Docket Item # 10
BAR CASE # 2008-0061

BAR Meeting
July 30, 2008

ISSUE: Sign
APPLICANT: Potomac Trust Mortgage
LOCATION: 201 King Street
ZONE: KR/King Street Urban Retail

Figure 2 Sign Detail

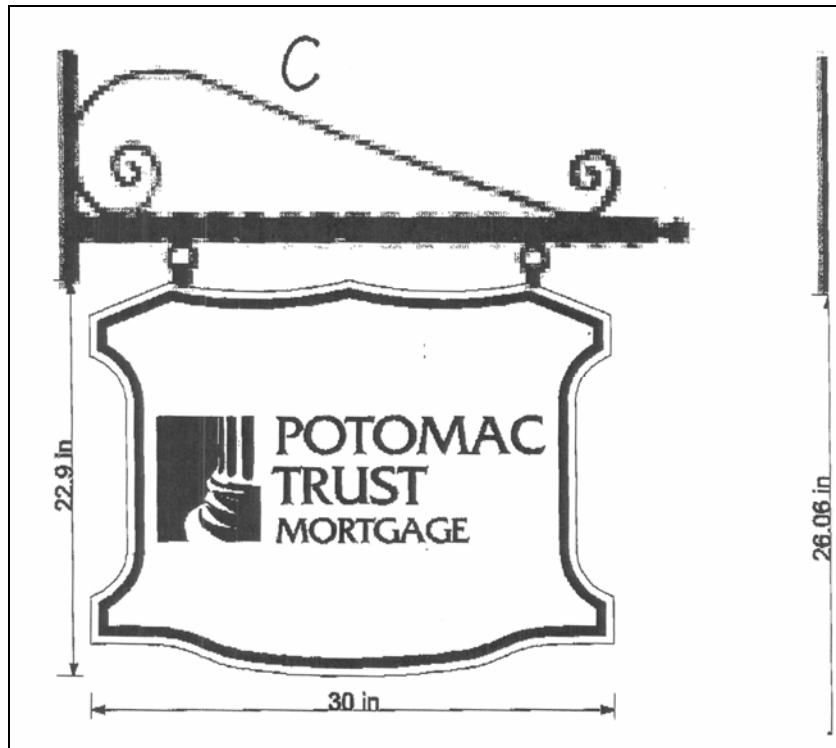
The applicant is requesting after-the-fact approval of a Certificate of Appropriateness for a hanging sign at 201 King Street. The double-sided wood sign measures 22.9” by 30” and was installed on a pre-existing black metal sign bracket projecting from the corner of the building at King and North Lee Streets. The sign is white with a black border, with the words POTOMAC TRUST in black text and the word MORTGAGE in blue text. The sign also includes an image of the base of a Doric column.

In the opinion of staff, the proposed sign meets the recommendations contained in the *Design Guidelines* for hanging signs. Staff recommends after-the-fact approval of the Potomac Trust Mortgage sign.

C-1 Projecting, hanging signs must comply with USBC [H103-H107, H112] for type of materials, maximum projection, vertical clearance below all parts of the sign, and additional loads.

Staff recommends after-the-fact approval of the Potomac Trust Mortgage hanging sign.
